STAFF REPORT
(Preliminary Plat)

CASE NUMBER: SUB 2007-115 -- VIA CHRISTI-WEST ADDITION

STAFF REPORT
(Final Plat, Preliminary Plat Approved 12/27/07)

STAFF REPORT

VIA CHRISTI
254-87 K-8234-01
SEDGWICK COUNTY
SW 1/4, SEC 2, T27S, R2W
2-13-08

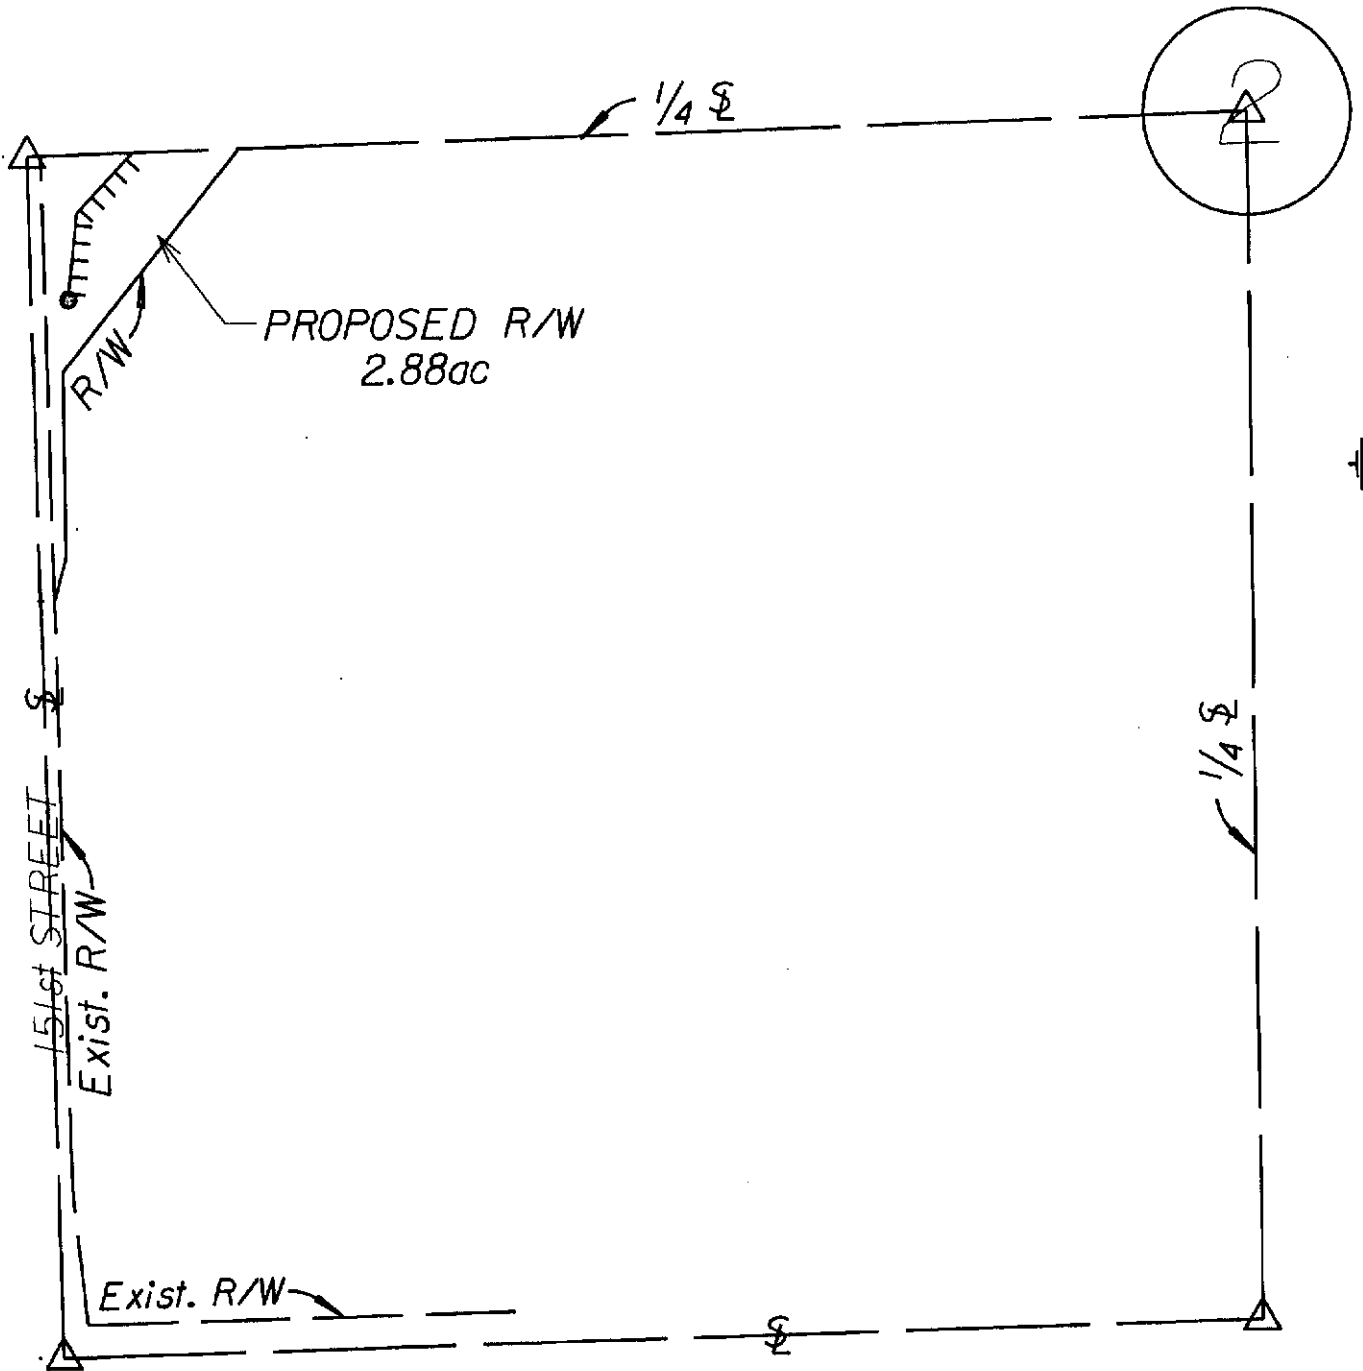
We are proposing and offering to plat a building setback along the area of your future right-of-way to ensure that Via Christi can not develop a building in the area. Can you please prepare a legal and/or exhibit that you would like us to use for a building setback line?

As requested we've provided a description of the proposed right-of-way across the property you are platting. If you need additional information beyond this please let me know and we will provide what we can.
